VILLAGE STAFF REPORT OF JULY 13, 2015

The petitioner is requesting several approvals for the development of the 2.01 acre site located at the southeast corner of STH 50 and 94th Avenue (Outlot 21 of Prairie Ridge Subdivision) based on the Conceptual Plan that was conditionally approved by the Village Board on June 1, 2015 for the development of two (2) retail/restaurant buildings on the property generally located at the southeast corner of STH 50 (75th Street) and 94th Avenue within the Prairie Ridge development. The approvals being considered by the Plan Commission at this meeting include a Certified Survey Map, a Zoning Text Amendment and Preliminary Site and Operational Plans.

TO: Jean Werbie-Harris, Community Development Director
FROM: Doug McElmury, Chief Fire & Rescue Department
CC: Deputy Chief, Craig Roepke
Lt. Thomas Clark, Fire & Rescue Department
Peggy Herrick, Assistant Planner, Community Development
SUBJECT: Review of the Preliminary Site and Operational Plan for Out lot 21, Multi-tenant Retail
DATE: 10 July 2015

2015.0011.01
SHEET
C-11

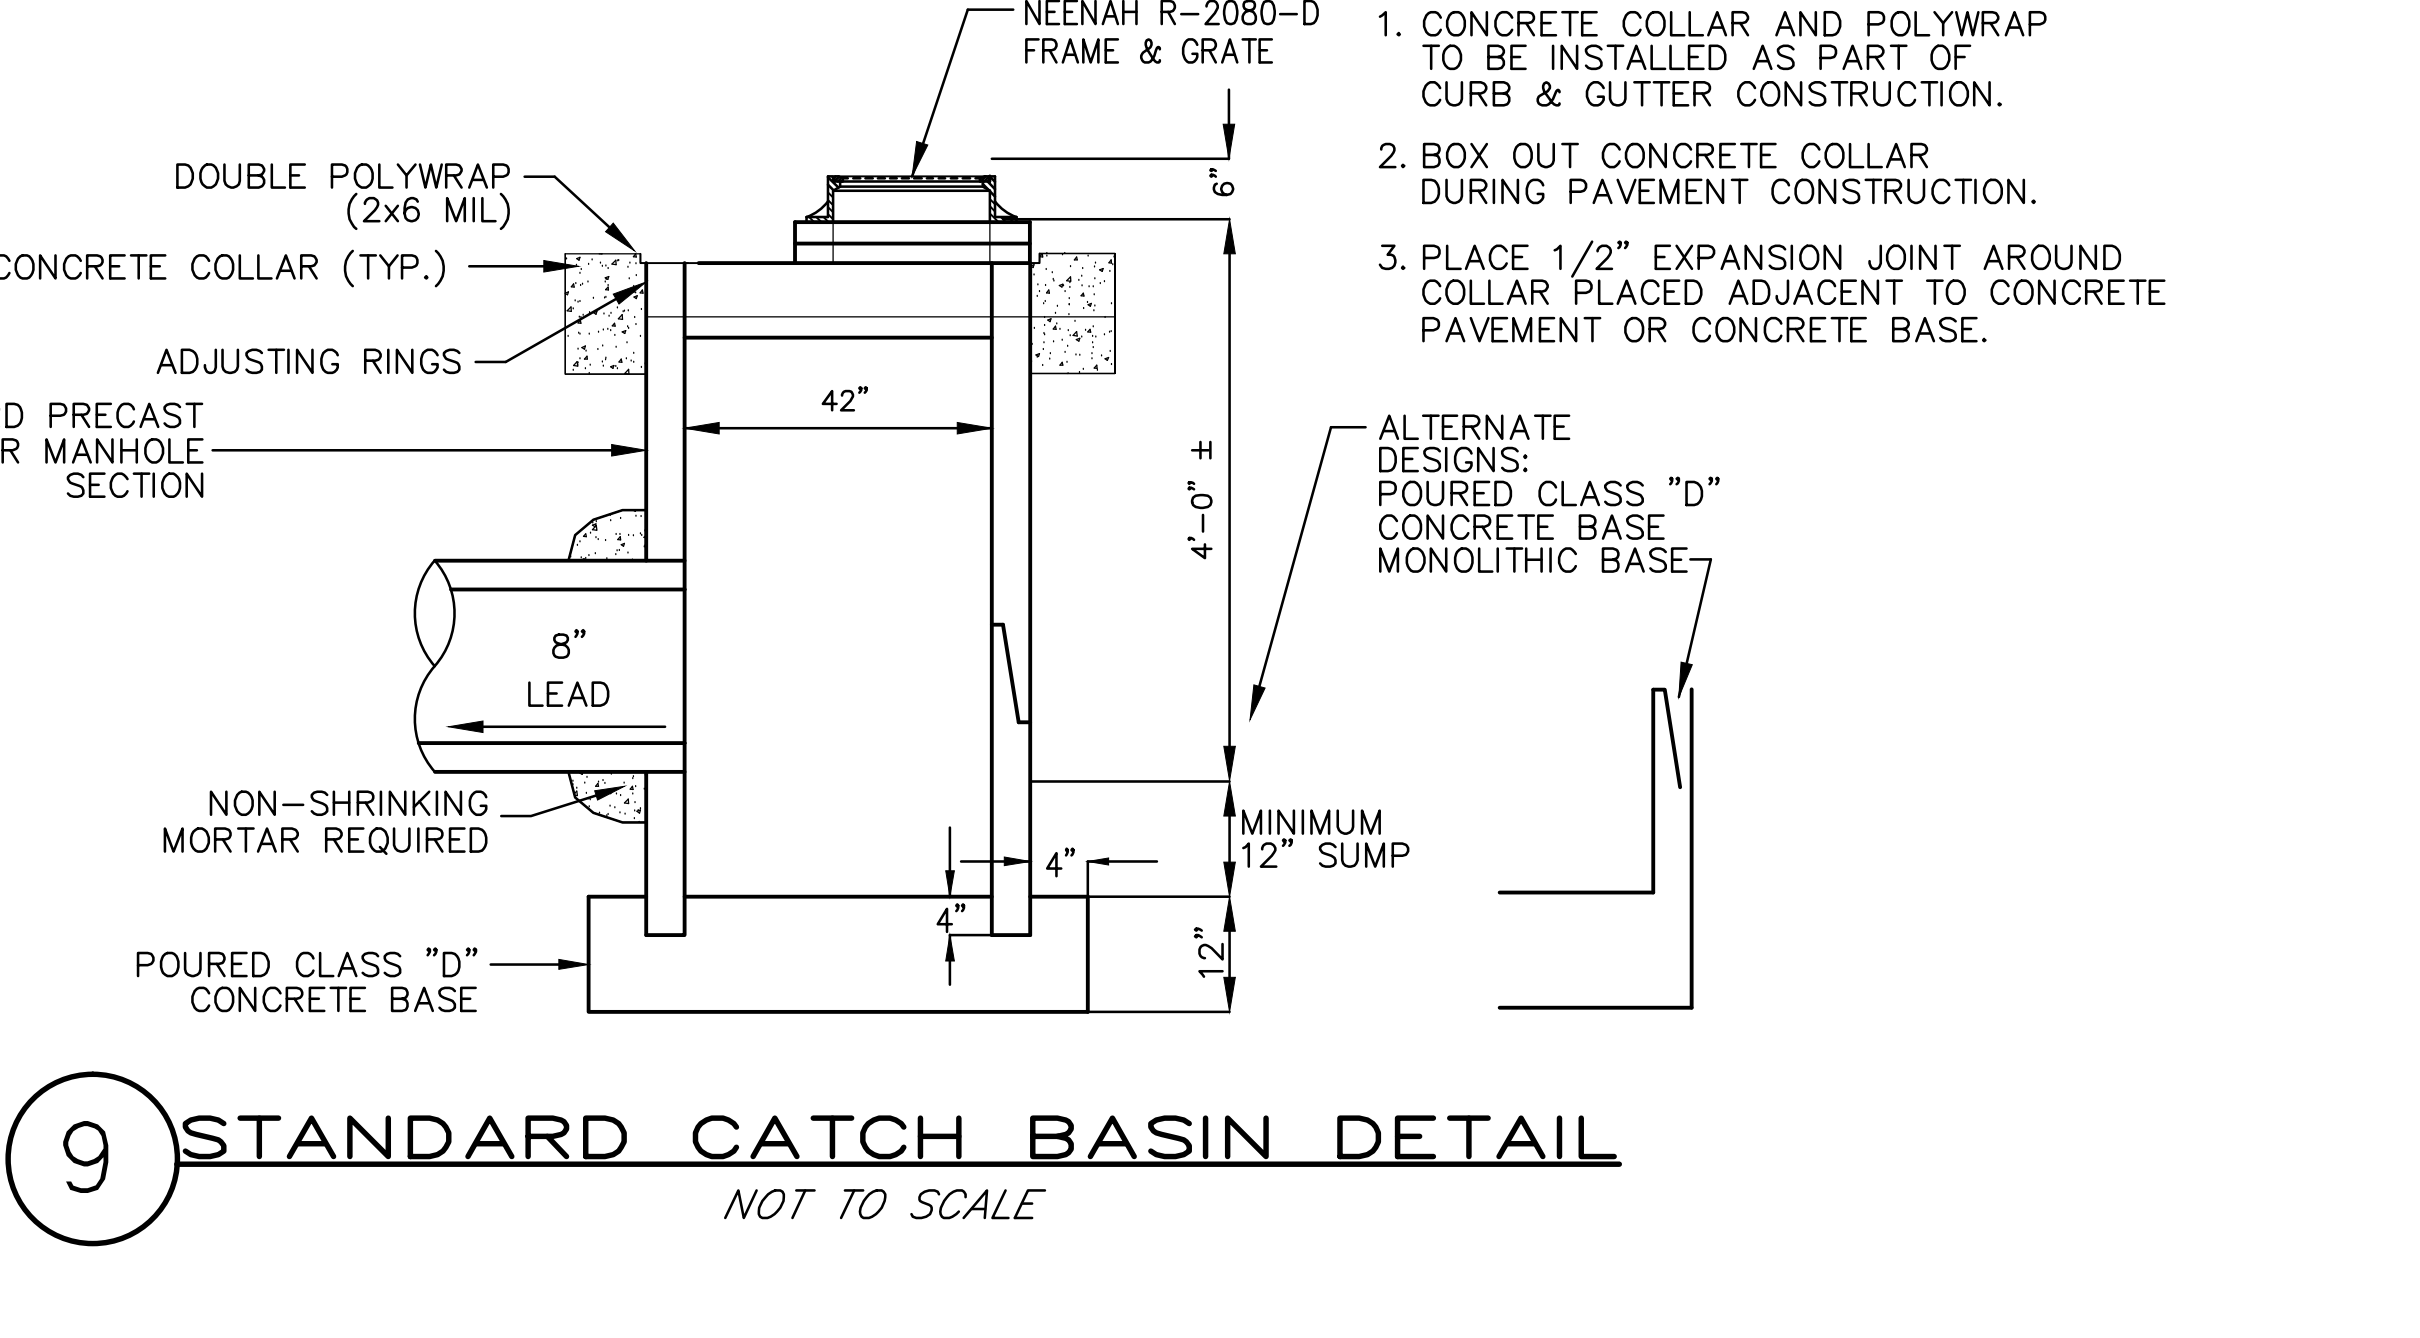
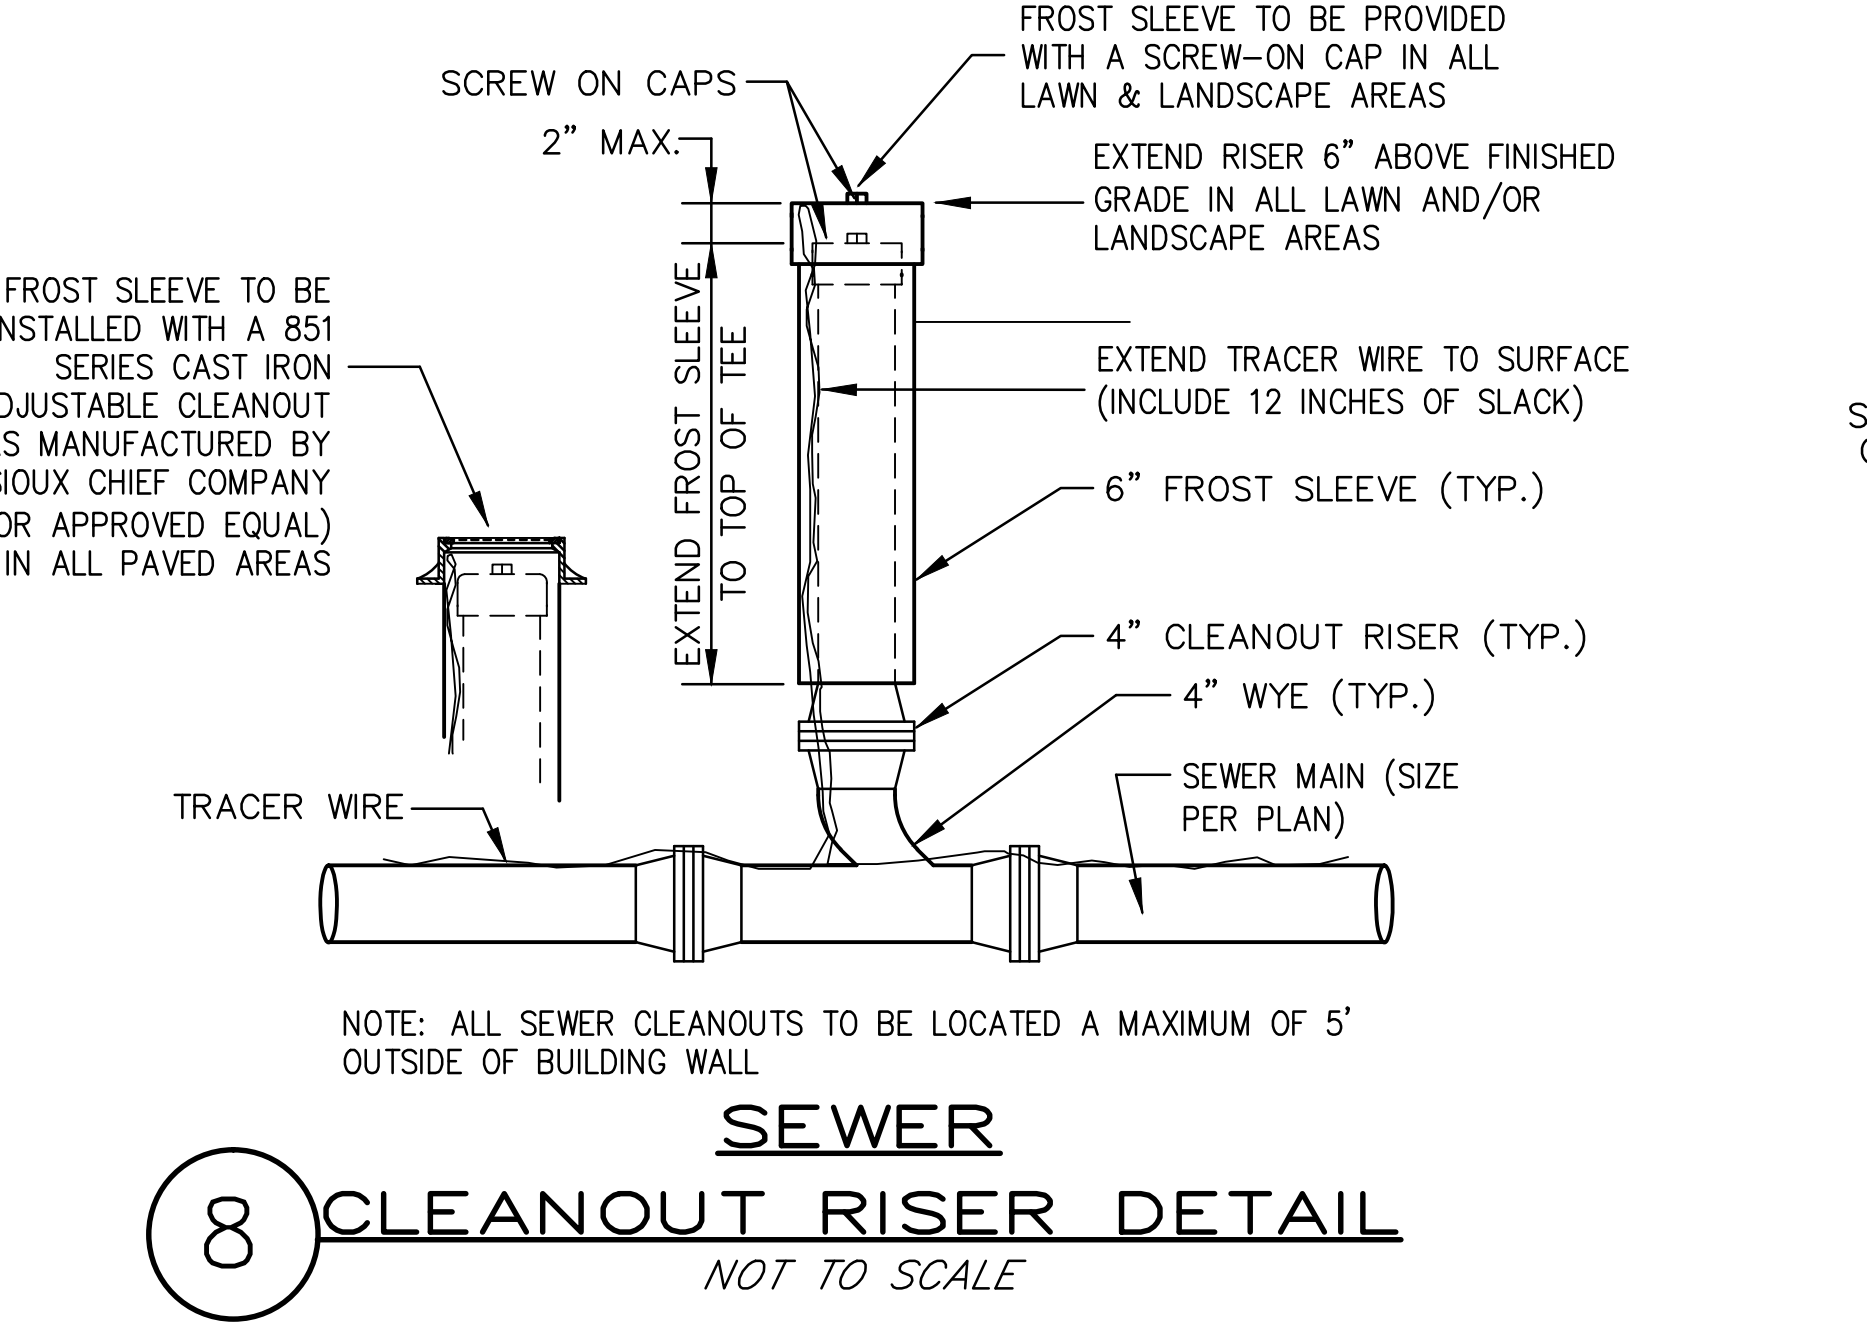
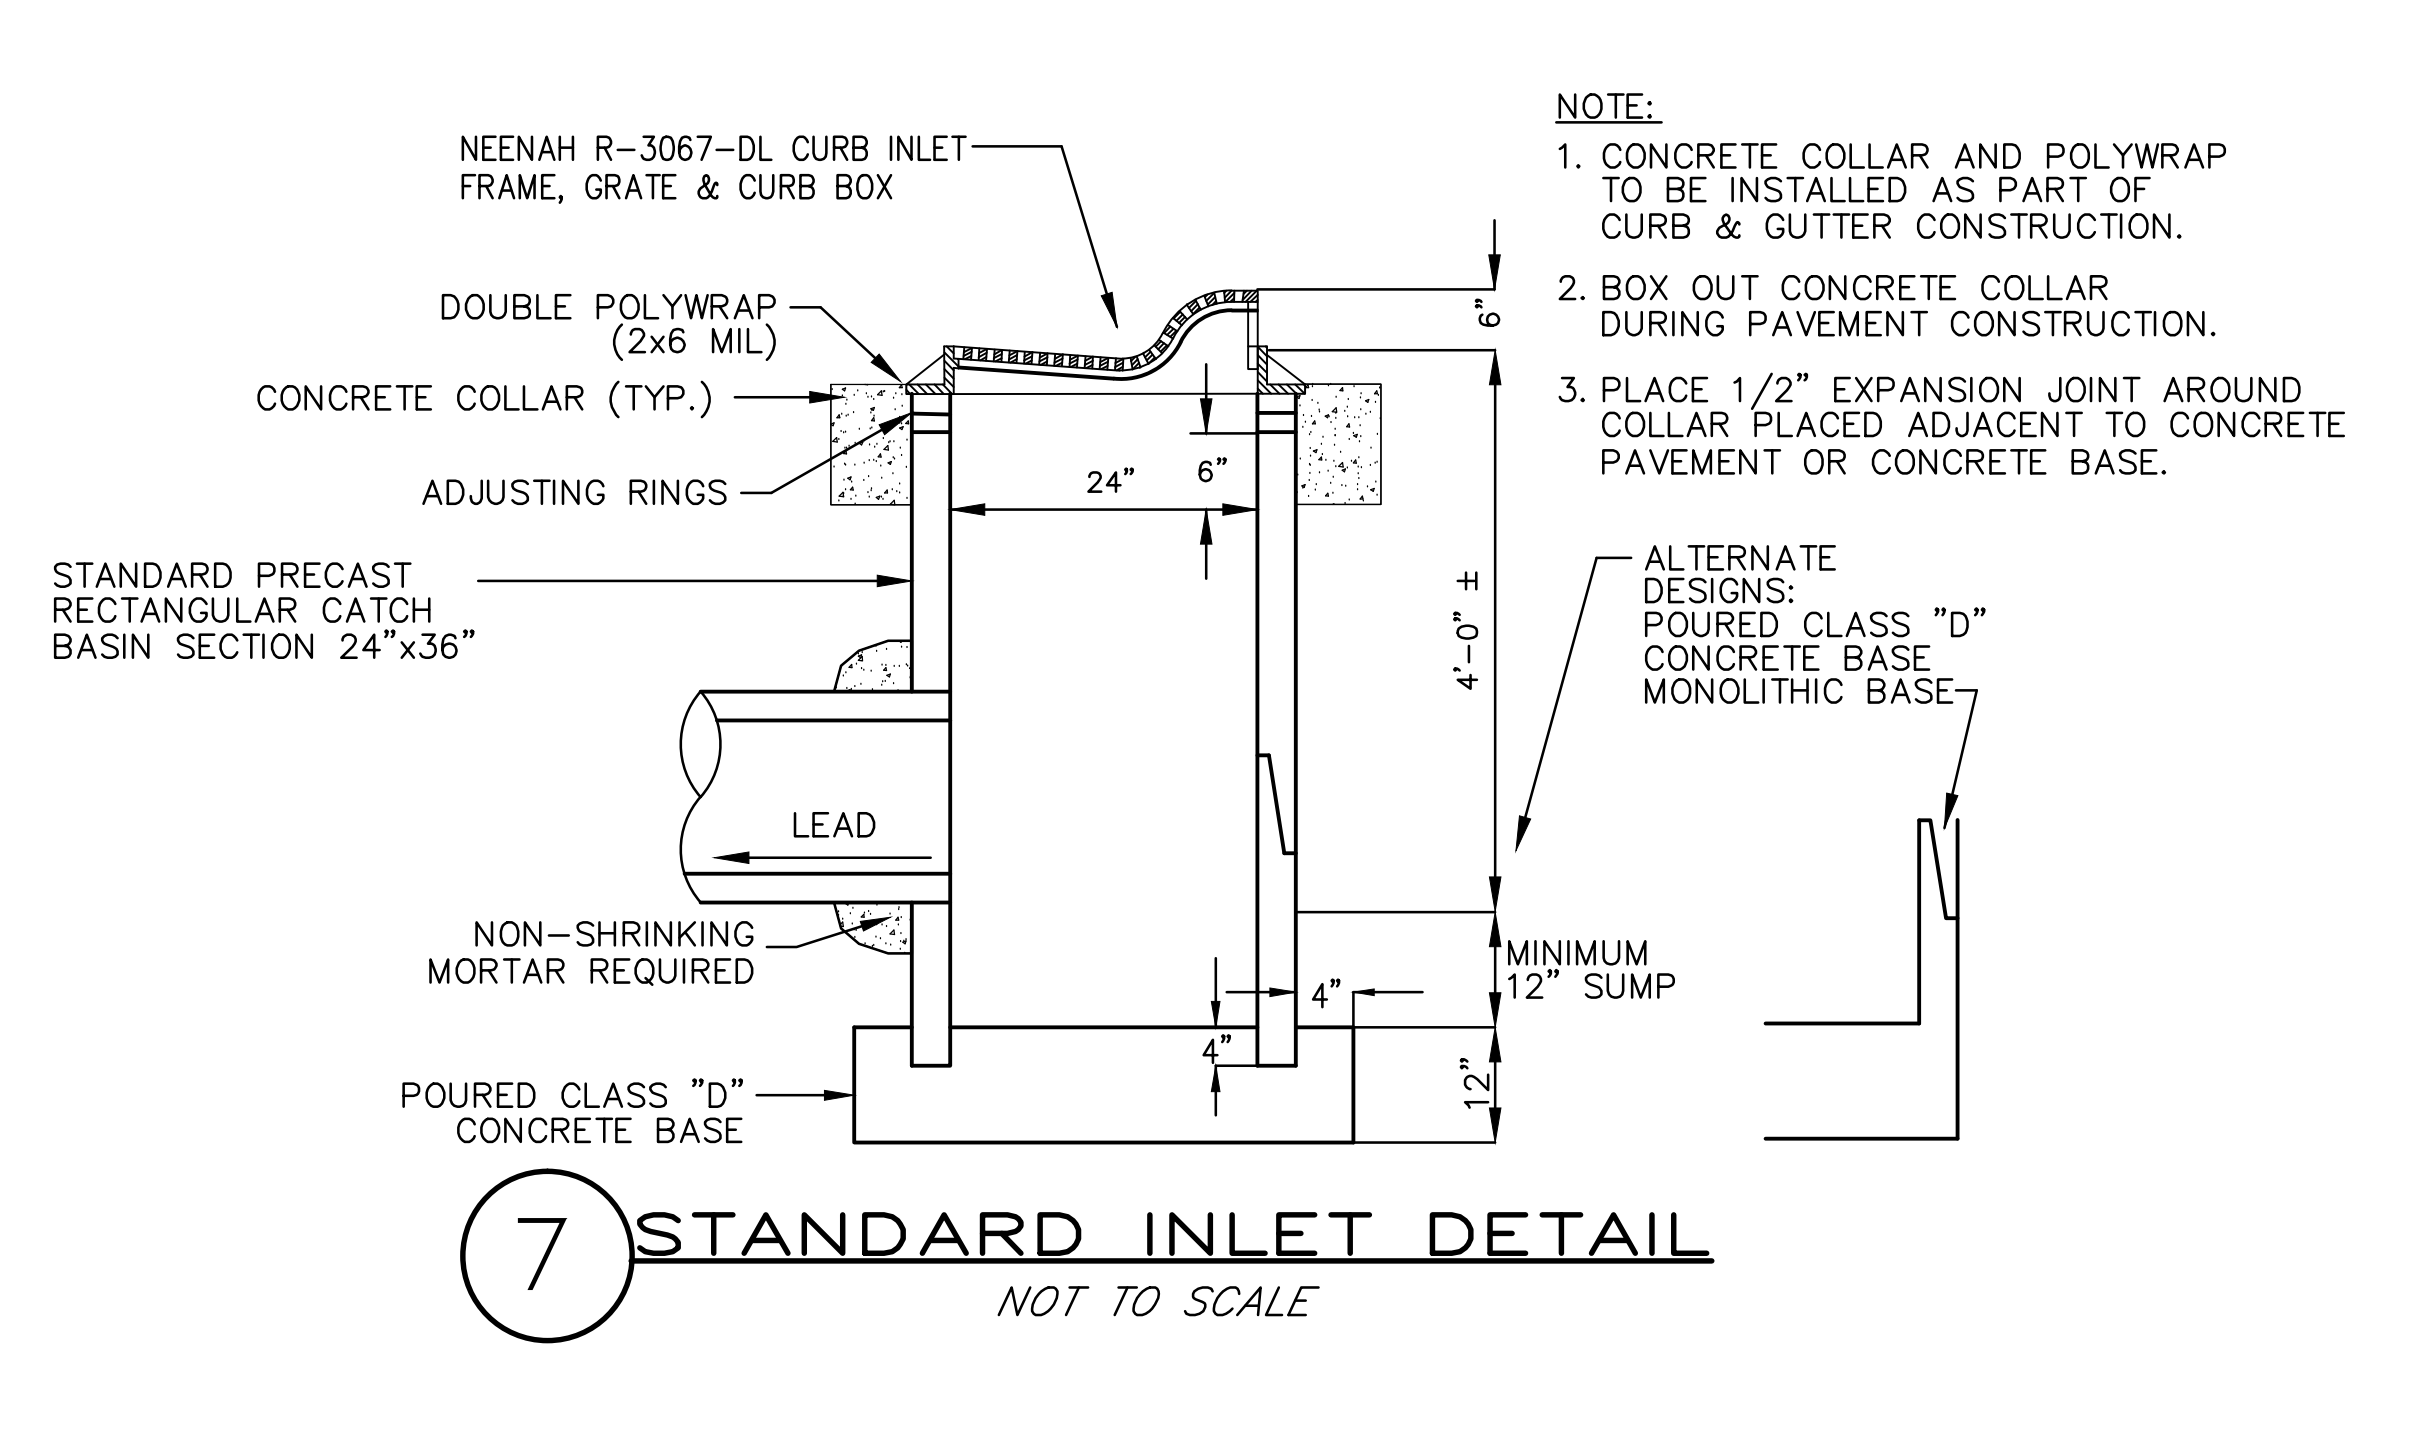
- m. On the Typical Sections and Construction Details (Sheet C-11): Is the casting on the standard inlet detail correct? The detail shows a casting for roll type curb with a width of 24" but the plans call for 18" vertical faced curb and gutter.

- Drawing C-11 shows the incorrect Remote FDC at the Pumper Pad. The FDC shall be built per the current Village Specification including a single 5" storz.
